## NORTHERN BEACHES LOCAL PLANNING PANEL

**WEDNESDAY 5 MAY 2021**

ITEM 3.1	DA2020/1136 - 13 PACIFIC ROAD, PALM BEACH - DEMOLITION WORKS AND CONSTRUCTION OF A DWELLING HOUSE
AUTHORISING MANAGER	Anna Williams
TRIM FILE REF	2021/296750
ATTACHMENTS	1 Assessment Report 2 Site Plan & Elevations 3 Clause 4.6

Figure 1: Height blanket detailing the extent of non-compliance with the 10m height limit

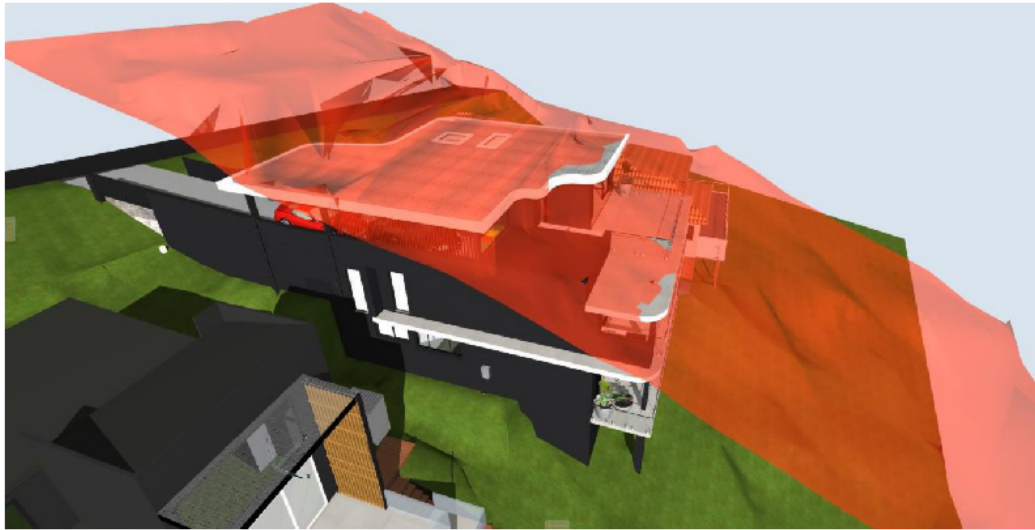
Provided at Figure 1 below is an extruded height blanket which details the portions of the dwelling that project above the maximum 10m requirement, noting that these relate to small portions of the roof to the ground and first floor levels.

In light of the above, the proposal seeks a departure of 0.59m from the maximum permitted building height standard and a variation of 5.9% relating to the small encroaching elements identified at Figure 1 above.

**Figure 1** – Extent of building height breach adjacent to the Condamine Street frontage

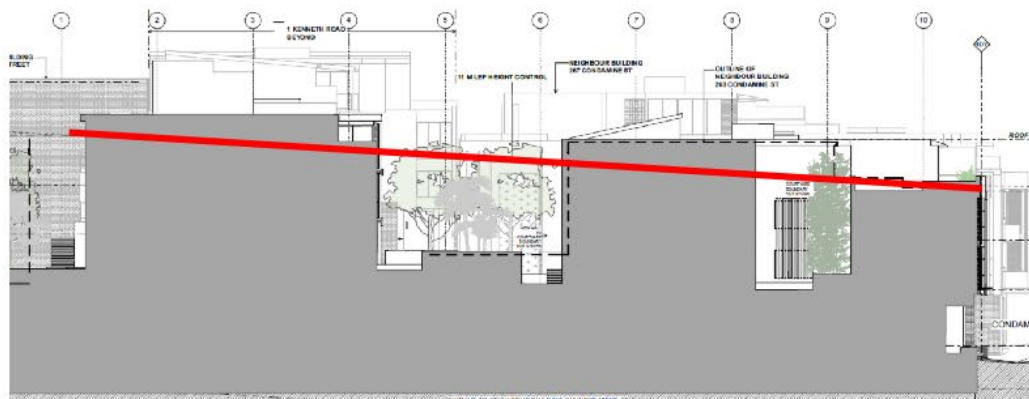
The proposed development has a variable street facing parapet height of between 13.2m and 13.5m to the Kenneth Road elevation and 11.2 and 11.6m to the Condamine Street elevation. The extent of building height breach increases beyond the front parapets to a maximum of 3.9 metres in the south western corner of the consolidated site where the site falls away from the Kenneth Road frontage.

The variable extent of the building height breaching elements is depicted on the elevations and sections at Figures 1 to 4 below and over page and the contextual building height breaching diagrams at Figure 5.
